STAFF RECOMMENDATION
934 McFerrin Avenue
March 21, 2018

Application: Demolition—primary structure; New construction-infill
District: Greenwood Neighborhood Conservation Zoning Overlay
Council District: 05
Map and Parcel Number: 08208010200
Applicant: Root Arch
Project Lead: Melissa Baldock, melissa.baldock@nashville.gov

Description of Project: Application is to demolish a non-contributing house and to construct a development with six structures and twelve residential units. **Recommendation Summary:** Staff recommends approval of the demolition of the existing structure on the lot, finding that its demolition meets Section III.B.2. of the design guidelines. Staff recommends disapproval of the new construction, finding that the proposed development does not meet Sections II.B.1.a (Height), II.B.1.b. (Scale), II.B.1.c. (Setback & Rhythm of Spacing), II.B.1.f (Orientation), II.B.1.g. (Proportion and Rhythm of Openings), and II.B.1.k. (Multi-unit Detached Developments/ Cottage Developments) of the design guidelines for the Greenwood Neighborhood Conservation Zoning Overlay.	**Attachments** **A:** Photographs **B:** Site Plan **C:** Elevations

EAST ELEVATION - UNIT 2

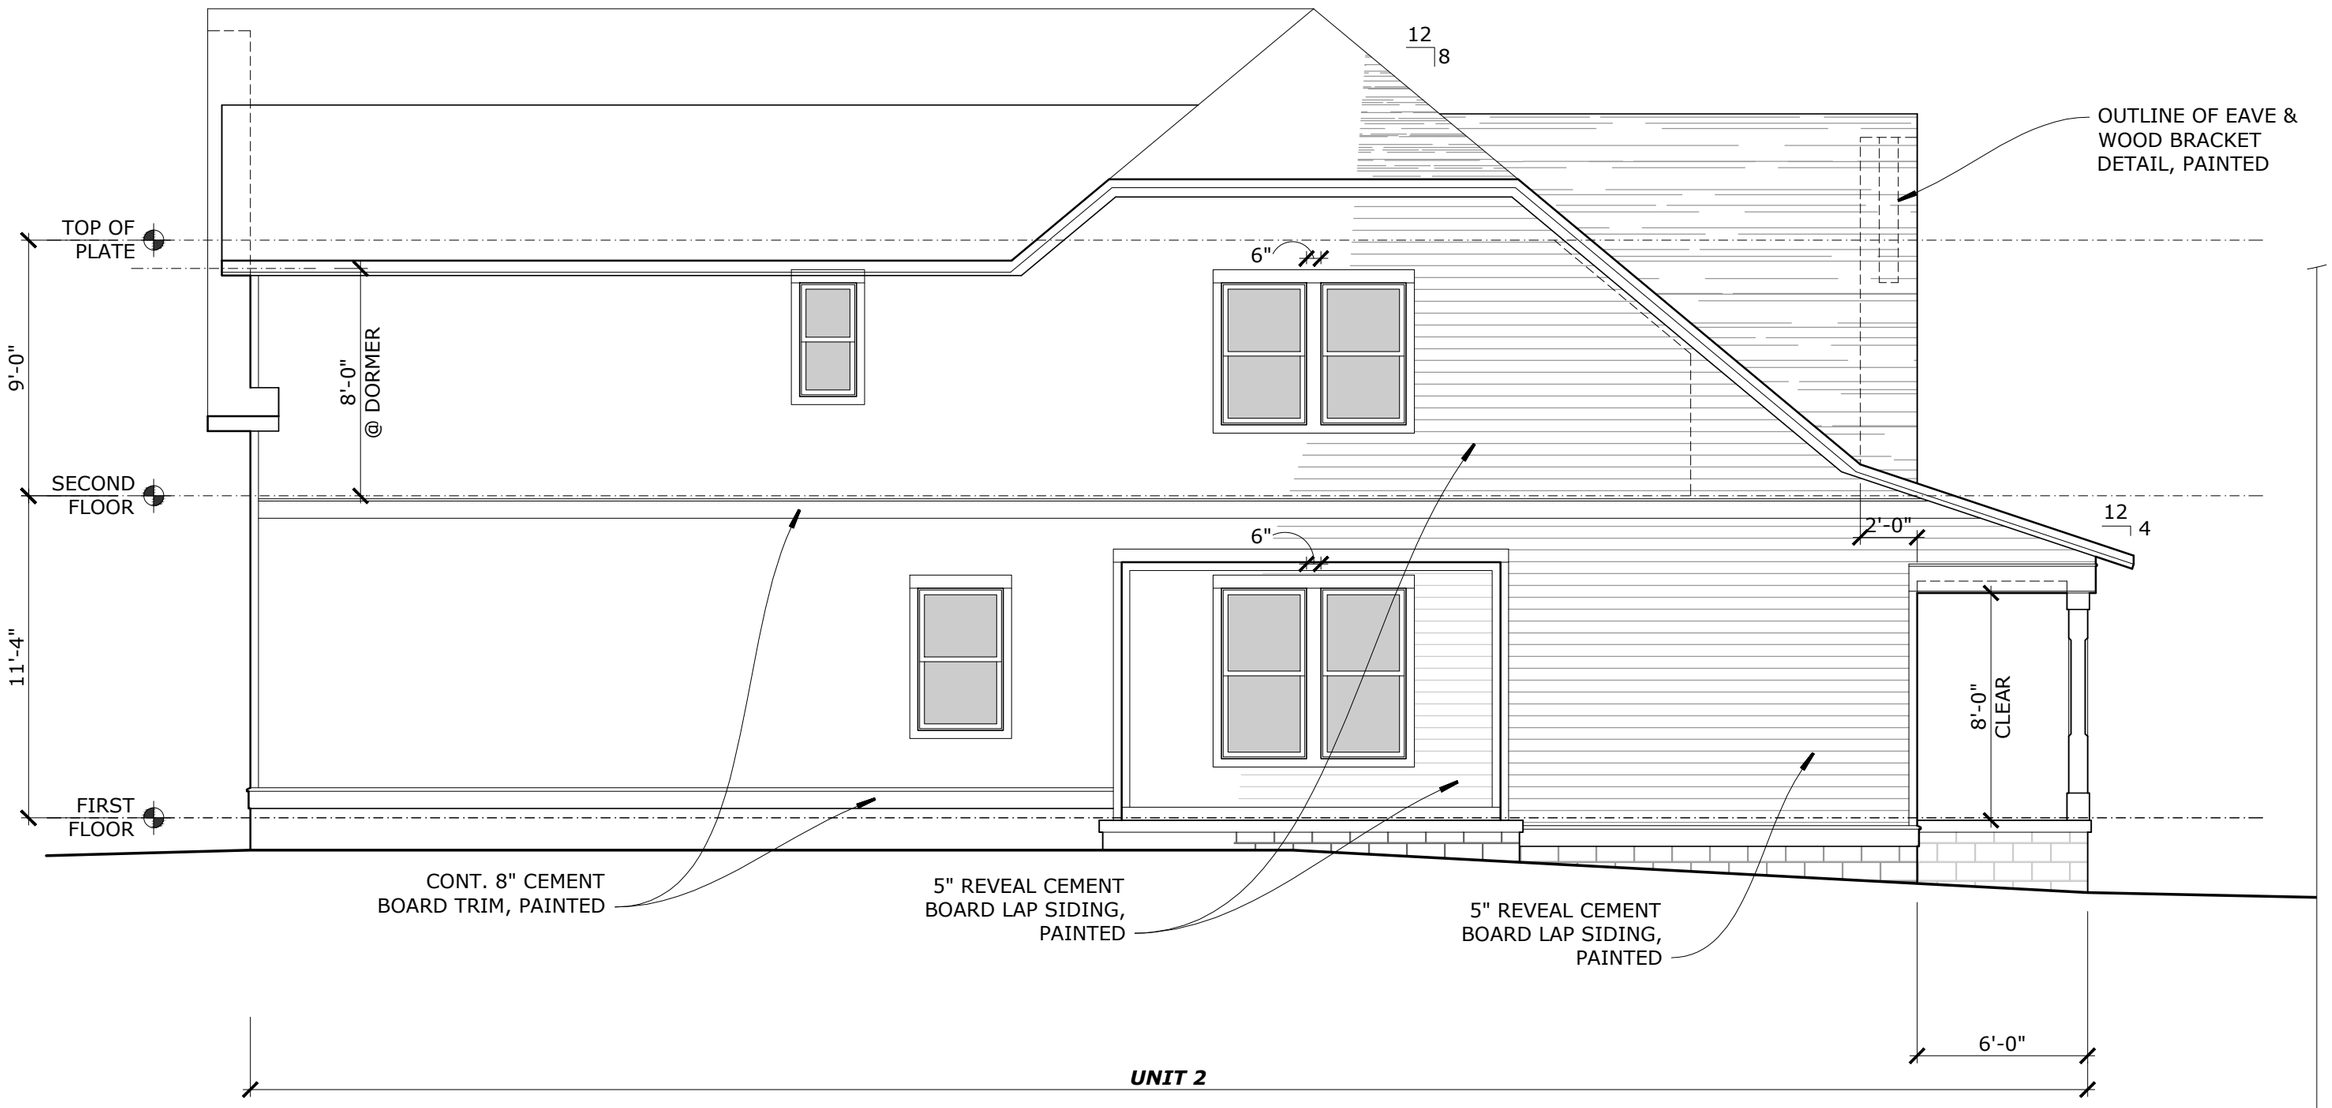
The units facing Seymour Avenue all have front porches that are a minimum of six feet (6') deep. Units 1 and 2 share the same porch roof, but have porch floors that are separated by two feet (2') of space. Units 3 and 4 have a similar porch configuration. In looking at historic duplexes, typically, either the porches shared the same floor and the same roof, or the porch roofs and the porch floors were entirely separate. Staff finds that the separate porch floors under the continuous porch roof increase the perceived width of the houses and are not appropriate.

Staff finds that the overall heights and number of stories of the units facing Seymour Avenue could be appropriate, as there are a handful of historic houses that are between thirty and thirty-four feet (30'-34') tall in vicinity and there are no historic buildings on the block-face. However, staff finds the proposed widths of forty feet (40') for Units 1 – 6 are too wide and do not meet the historic context. There are no historic houses wider than thirty-seven feet (37') in the immediate vicinity. Even though Units 3 & 4 and 5 & 6 are designed so that they have a narrower width at the front, the maximum width of forty feet (40') occurs not far back from the front and will be easily perceived on the street. The proposed widths result in houses that are over-scaled for the historic context. Moreover, the widths of forty feet (40') create a situation where the houses are too close together and are too close to the McFerrin Avenue property line.

SEYMOUR AVENUE ELEVATION - UNITS 5-6

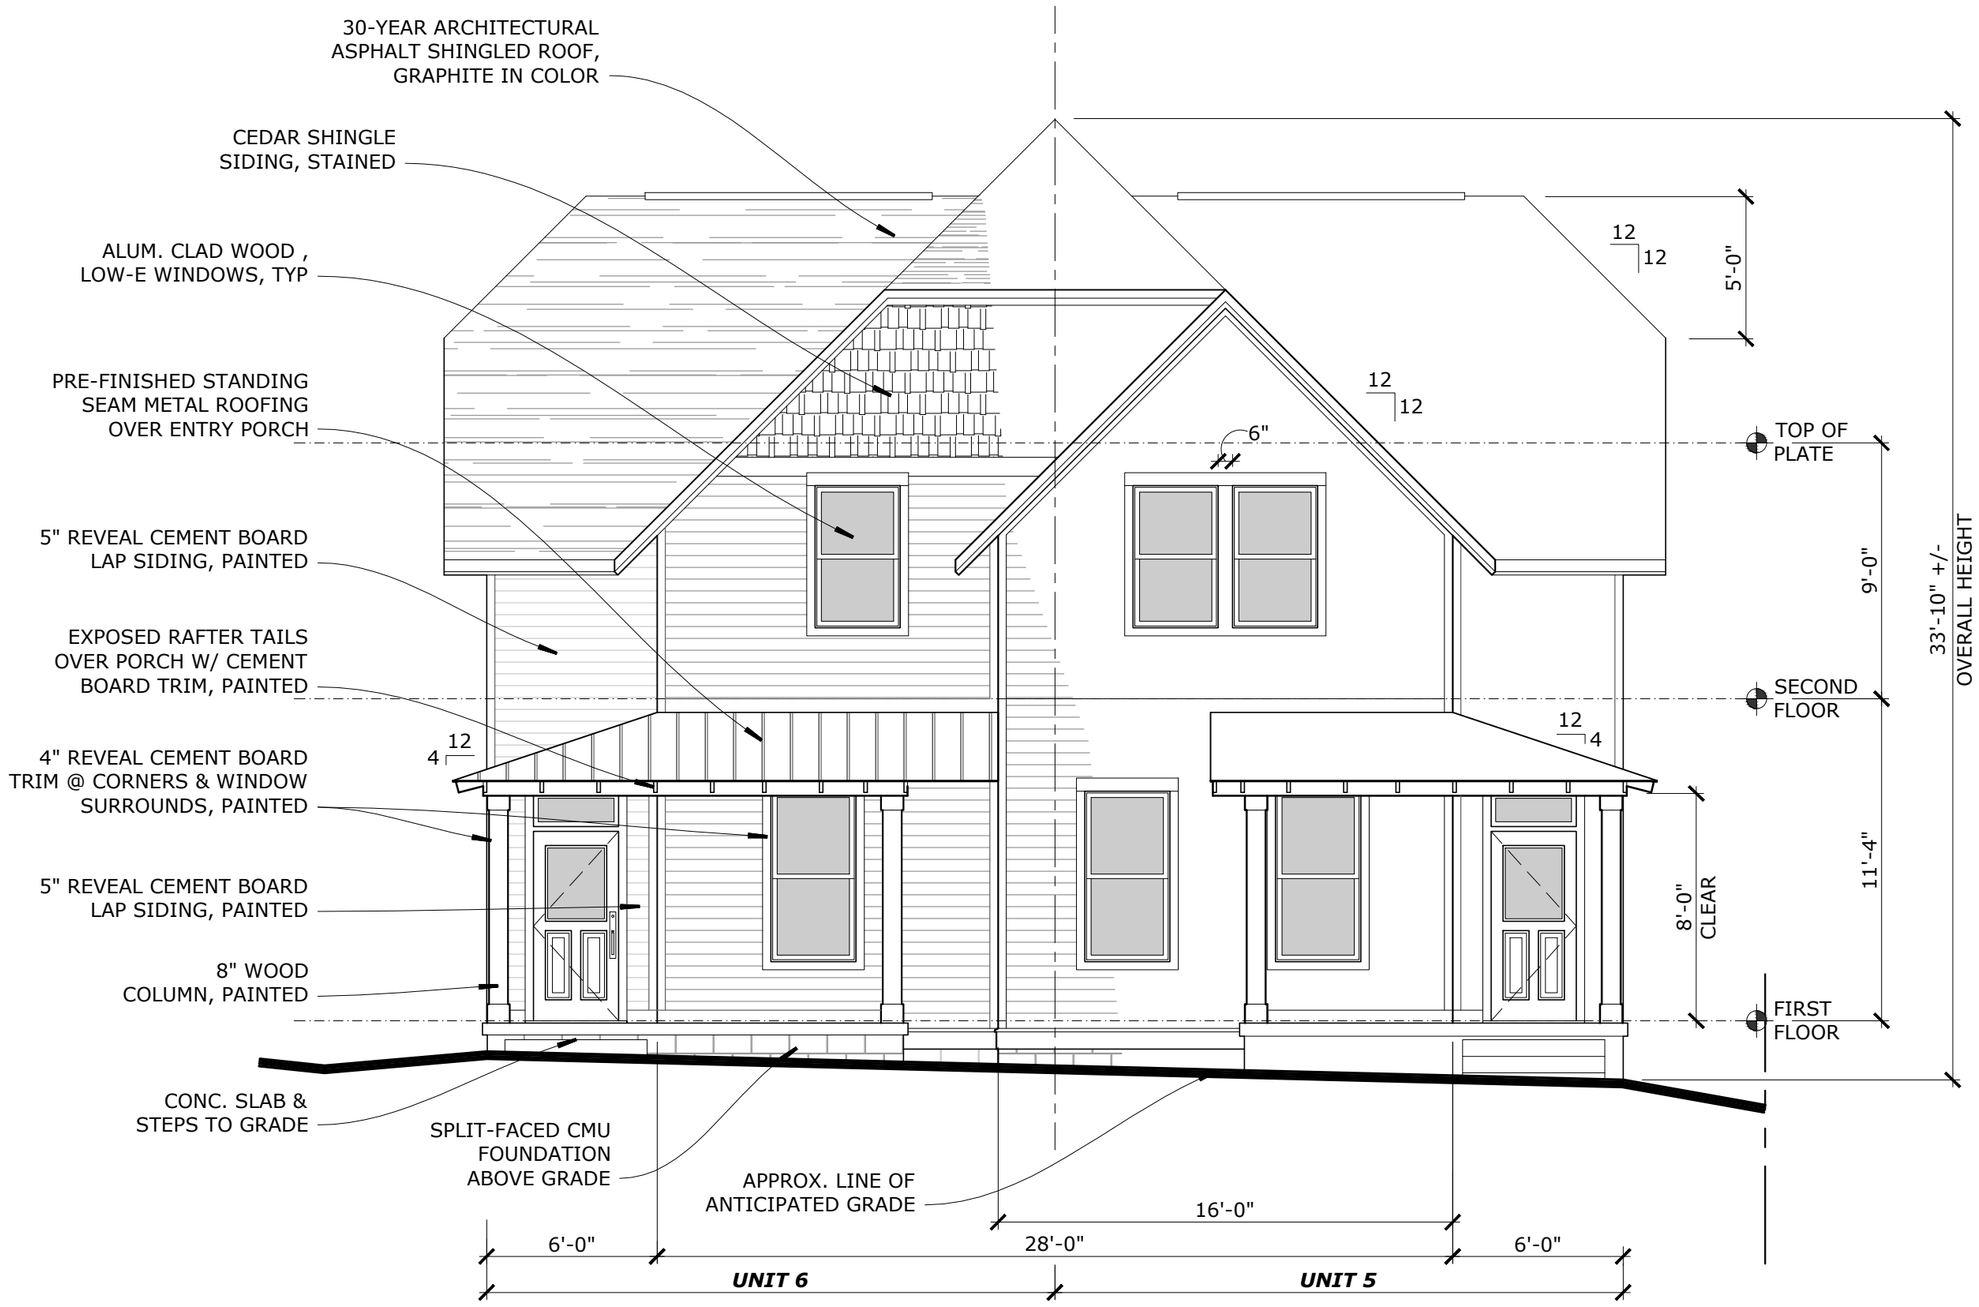
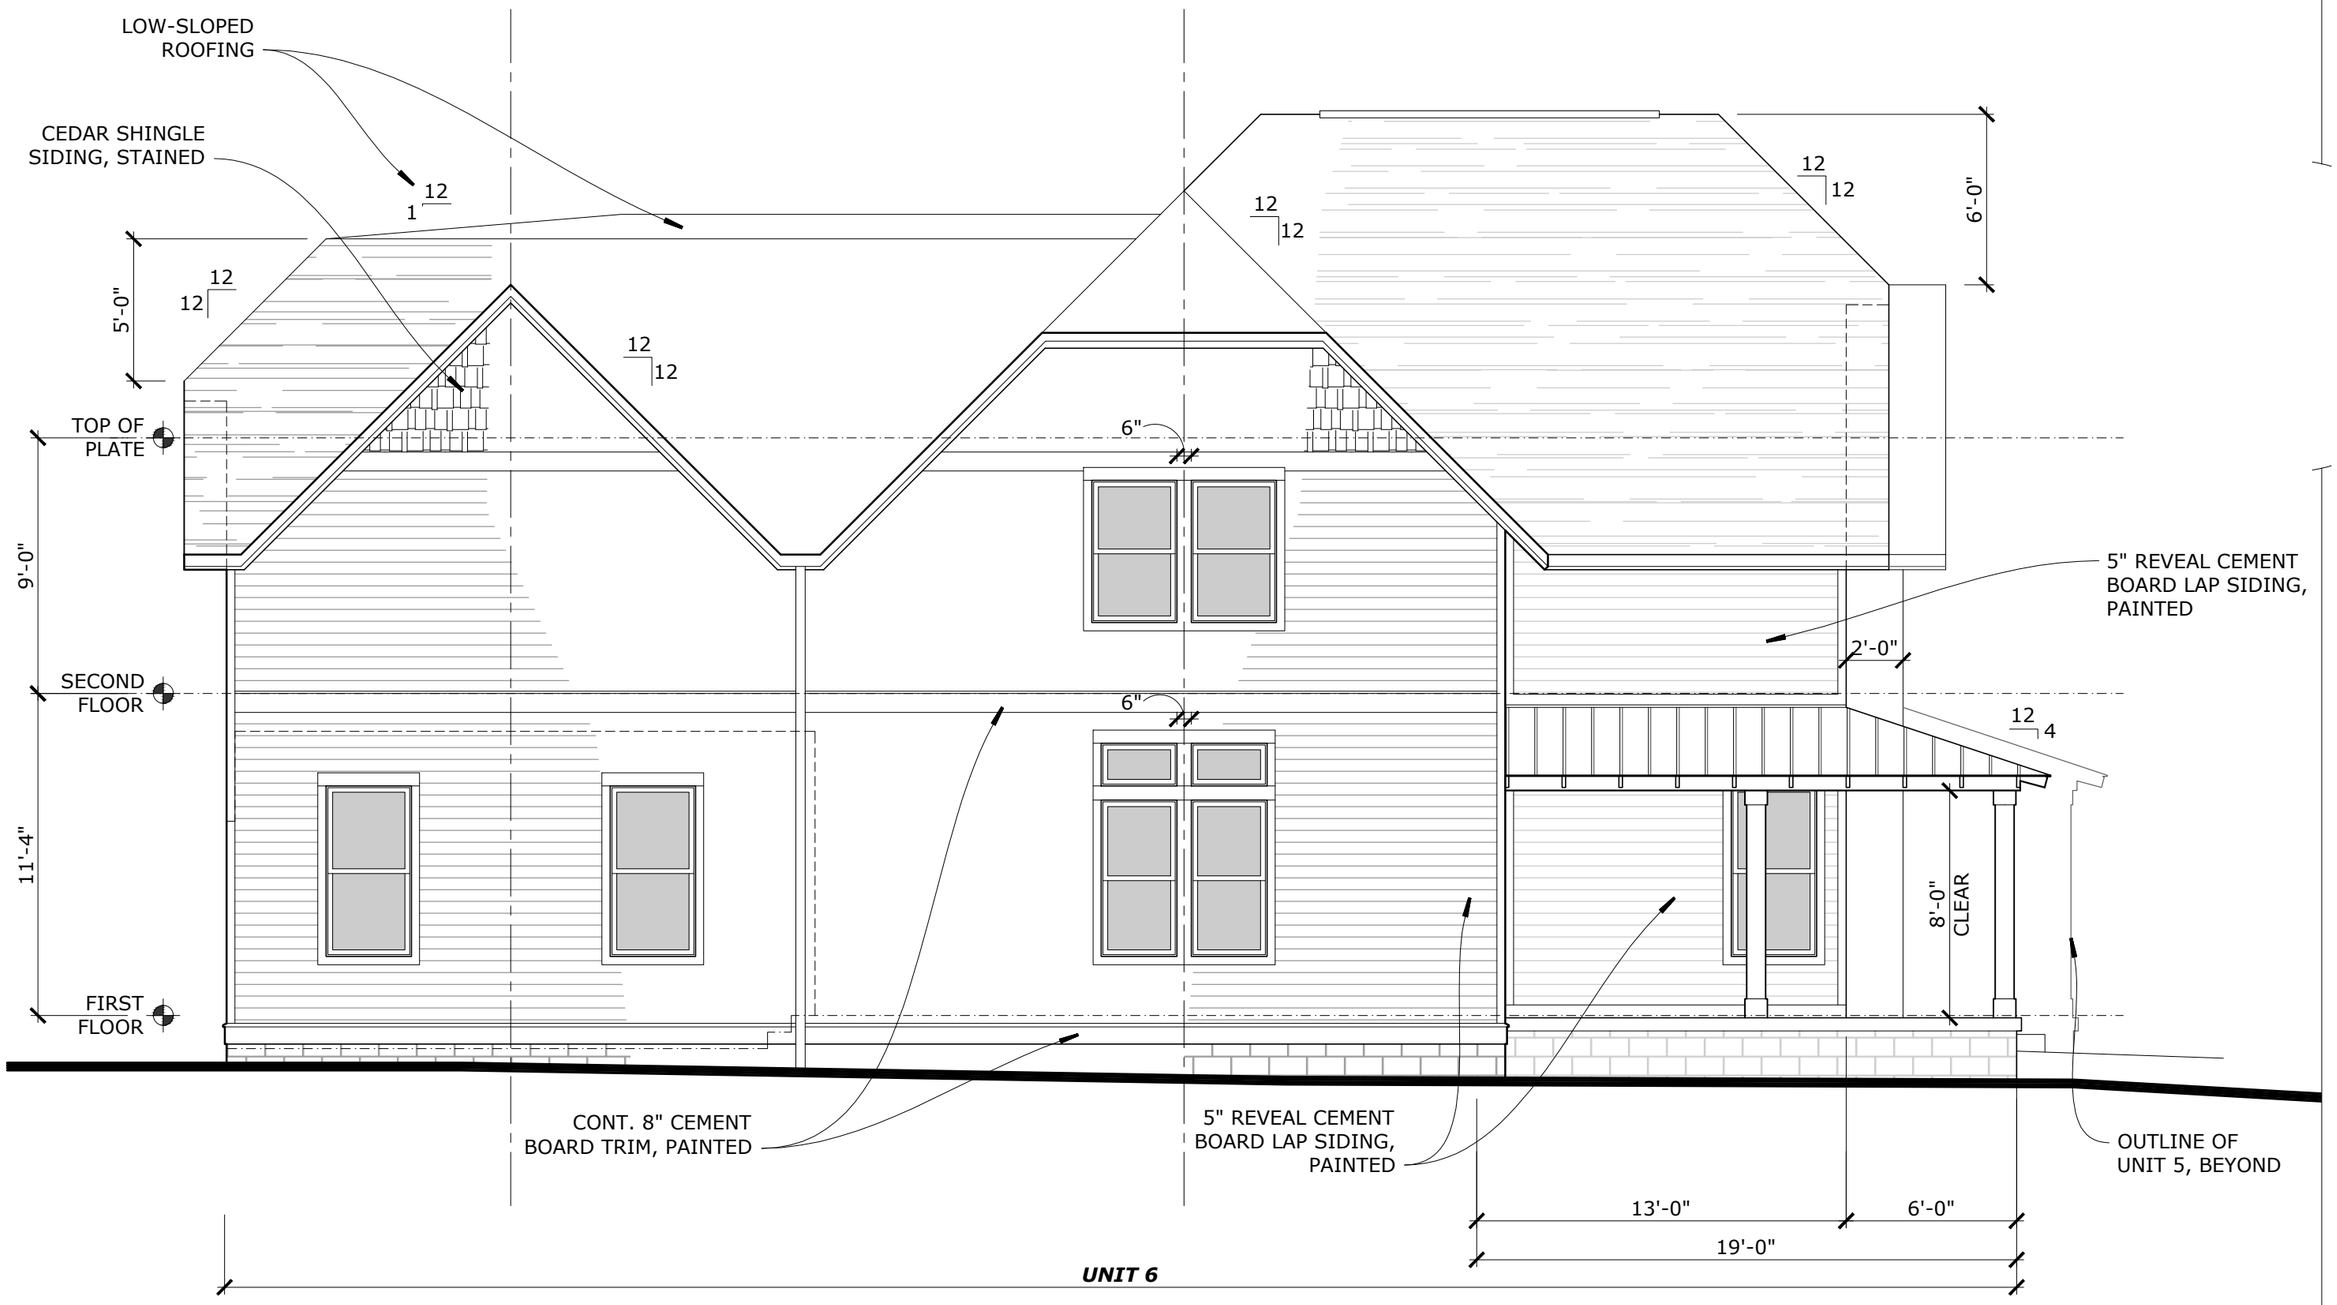
Most of the units facing Seymour Avenue have walkways leading from the front porches to the sidewalks. However, Unit 6, which is located at the corner of McFerrin and Seymour Avenue, has a corner entrance and one walkway leading to the sidewalk along McFerrin Avenue. In order for the project to meet the design guidelines and to address both streets, Unit 6 should have one walkway to Seymour Avenue and one walkway to McFerrin Avenue.

The wider sidewalk requirements will affect the setbacks of the structures, particularly along McFerrin Avenue where the Unit 6 (facing Seymour Avenue) is just nine feet (9') from the side property line. Given the required sidewalk width along McFerrin Avenue, Unit 6 should likely be pushed further back from McFerrin Avenue. Staff requires a revised site plan with the correct sidewalk information in order to fully understand the layout of the houses in relation to the sidewalk. The front setbacks, proposed to be twenty-nine feet (29') from Seymour Avenue are likely appropriate, even with the wider sidewalk, since this 800 block of Seymour Avenue does not have any contributing buildings.
